**Submission to M12 Motorway Amendment Report October 2020  
State Significant Infrastructure Application Number: SSI – 9364**

**Proposed M12 Motorway interchange with M7 Motorway at Cecil Park  
Response to Amended EIS of 21 October 2020  
Impact on Watercourse adjacent to Barcas' Property, Cecil Road, Cecil Park**

### SUBMISSION TO M12 MOTORWAY AMENDMENT REPORT OCTOBER 2020 AS IT APPLIES TO NOS.18 TO 28 (LOTS 300 TO 304 DP 1122172) AND THE ADJOINING “RIVER’ CECIL ROAD CECIL PARK

**Figure 1:** Conceptual roundabout design at intersection between Cecil Road and Wallgrove Road

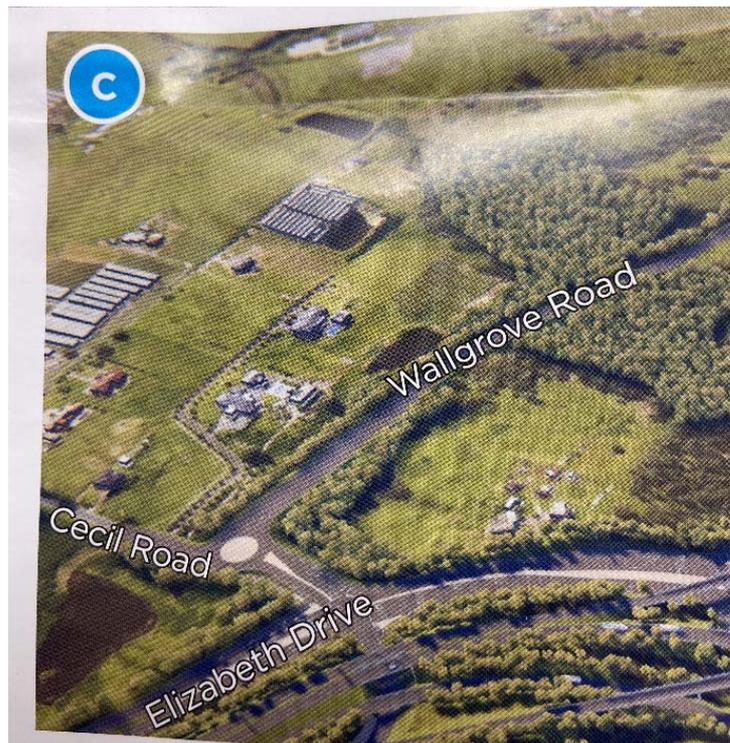
13. Our client has not been provided with any road designs other than a conceptual roundabout design at the intersection between Cecil Road and Wallgrove Road (See **Figure 1** below).

14. Based on recent discussions with Transport for NSW, our client has been informed the Amended Proposal will not include a roundabout at the intersection between Cecil Road and Wallgrove Road. This is inconsistent with Figure 1 above and what is depicted on Page 4 of Figure A-1 of the Amendment Report which clearly shows a roundabout at the intersection between Cecil Road and Wallgrove Road.

15. We submit that there is no certainty around the roundabout design and its location nor whether the roundabout forms part of the Amended Proposal.
16. Our client has also engaged Gary Rhodes, Town Planner of Rhodes Planning to prepare a submission. We **enclose** a copy of Mr Rhodes' submissions dated 28 October 2020 and we rely upon the submissions made by Mr Rhodes.

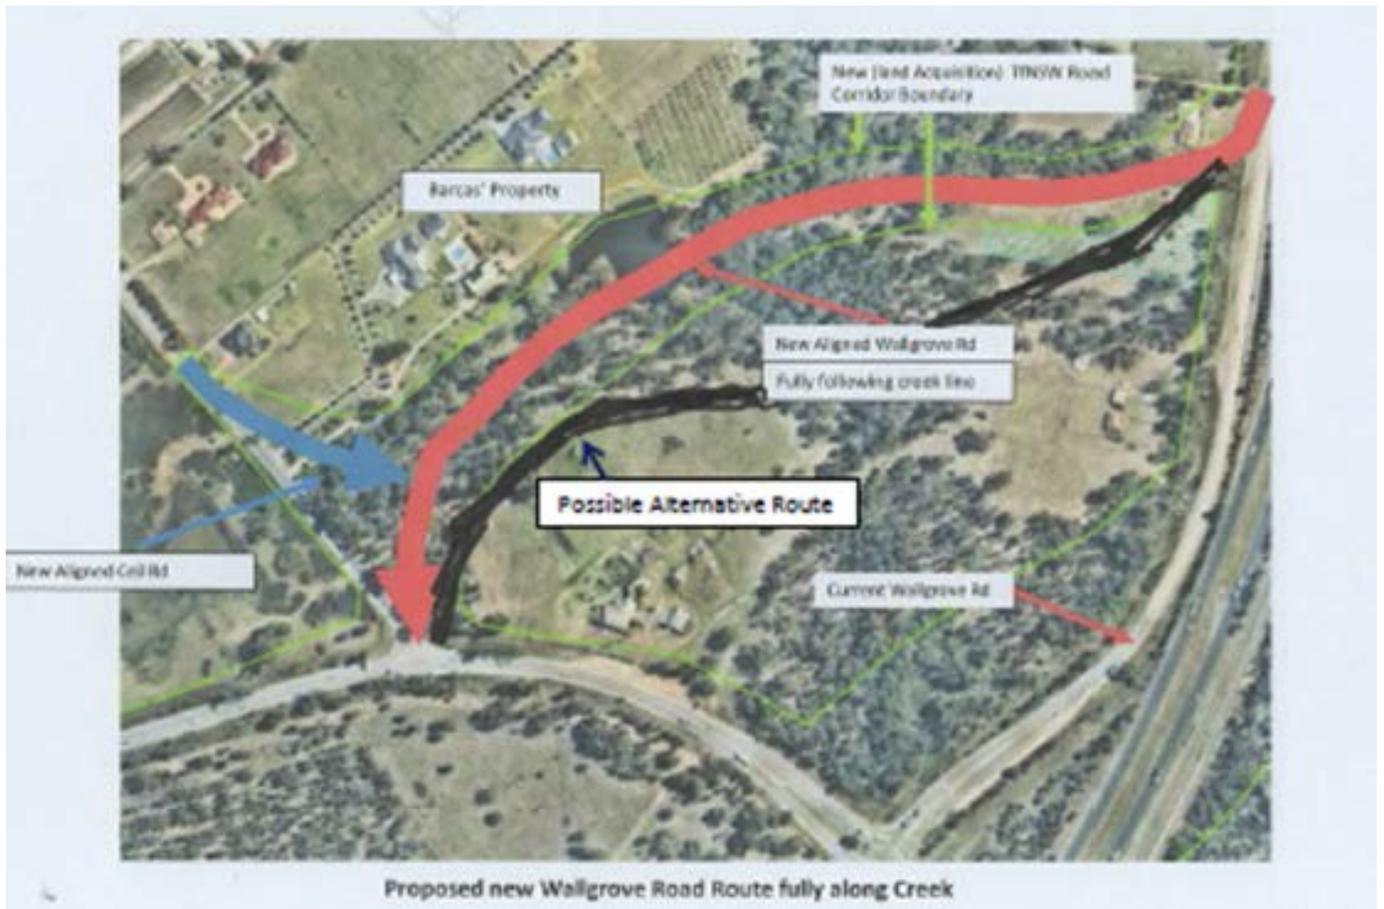
- Disturbingly, we were verbally advised by TfNSW on 26 October 2020, that the proposal for the Wallgrove relocation at its southern end connecting to Cecil Avenue and then Elizabeth Drive in the amended EIS of 21 October 2020 IS NOT the current one proposed by TfNSW but rather that shown in red on the aerial below ! However this decision is acknowledged as sound as it would provide an undesirable circuitous route for the significant Wallgrove Road route through to Elizabeth Drive; the roundabout at Cecil Avenue would reduce traffic capacity at the southern end, while the Wallgrove Road route along the creek would cause even greater environmental impact than the red route now advised as 'the' current proposal.

In particular, drawings displayed of the proposed relocation of Wallgrove Road did not justify why very apparent, logical alternatives, such as that shown in black on the aerial below would not be a preferred route for Wallgrove Road.

- A variation of the alternative abovementioned presented by TfNSW on 20 August 2020, shown blue on the aerial below, showed a change at the northern end only with assessment seemingly heavily biased to appear to have greater impact than the base proposal. Requests for copies of the varied proposal and assessment were declined as was any concept details for the proposed intersection of the new Wallgrove Road with Elizabeth Drive.

- Nevertheless a variation to the abovementioned TfNSW alternative was prepared which is illustrated below by an alternative centerline in black for Wallgrove Road on the TfNSW blue scheme. Comments thereupon related to the presentation by TfNSW are set out below:

- The TfNSW blue alternative moves the northern end of the original proposal but moves nothing at the southern end which is the more critical for impact on the Barca property, the creek, especially dam, and adjacent bush land.

- Alignment of southern end of Wallgrove Road relocation. An alternative alignment for the centreline of relocated Wallgrove Road is shown in black over the TfNSW blue proposal on the sketch below - this alignment brings the connection to Elizabeth Drive at 90 degrees to the same location. Further refinements include -

- i) Provide the section of Wallgrove Road across the nearby dam length in bridge structure with the bridge only in TfNSW strata title. Retain access under the bridge to provide continuity of the Western Sydney Parklands reserve physically and in ownership across (under) Wallgrove Road

- ii) Provide a carriageway on the relocated section of Wallgrove Road similar to that proposed on the existing Wallgrove Road planned for 2036 with narrow median and limit the road reserve of the relocated Wallgrove to that for the existing Wallgrove Road formation only i.e. to about 20 metres

**PLATE 1 – ORIGINALLY PROPOSED SUBDIVISION LAYOUT FOR NO. 111 ELIZABETH DRIVE CECIL PARK**

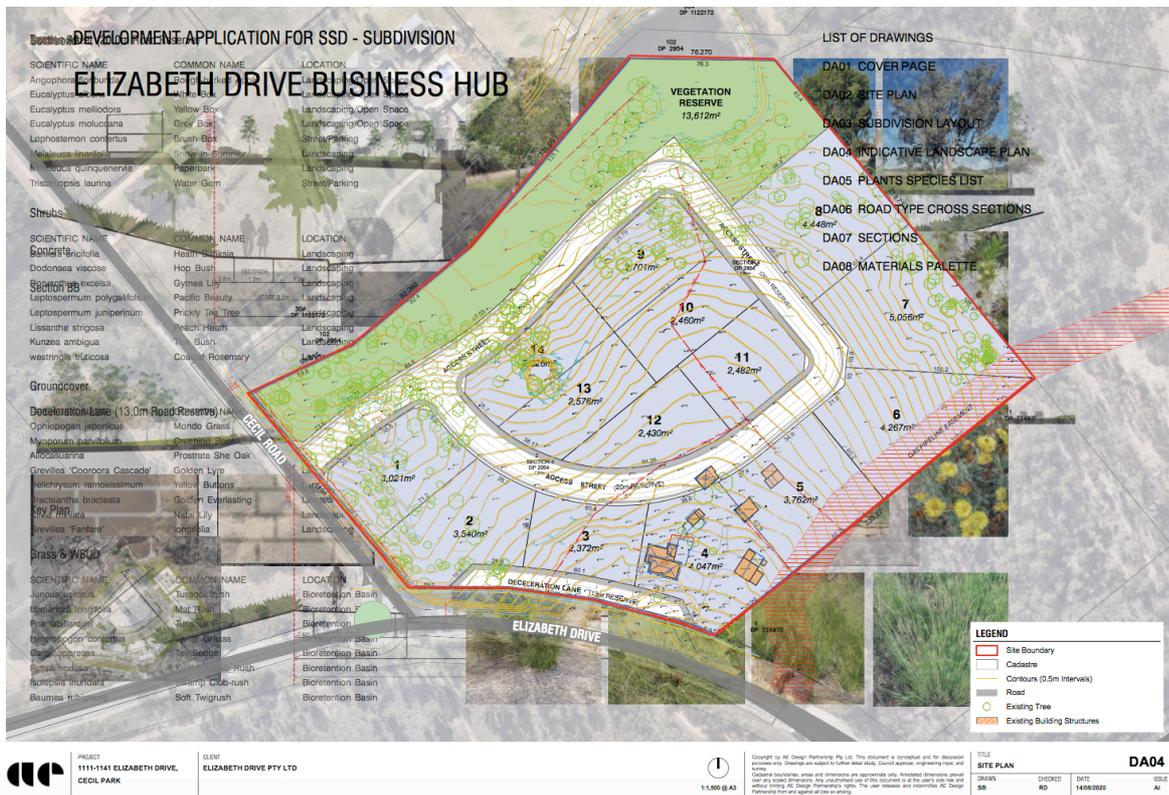
However, if the application has any contribution in respect of the Wallgrove Road deviation, perhaps it is the “proposed 20m wide road” running easterly off Cecil Road as depicted in the previous proponents EIS an extract of which is provided below as **Plate 1**. To my mind this generally demonstrates the alternate location for the deviation and there is minimal impact on the “River” and its environs.
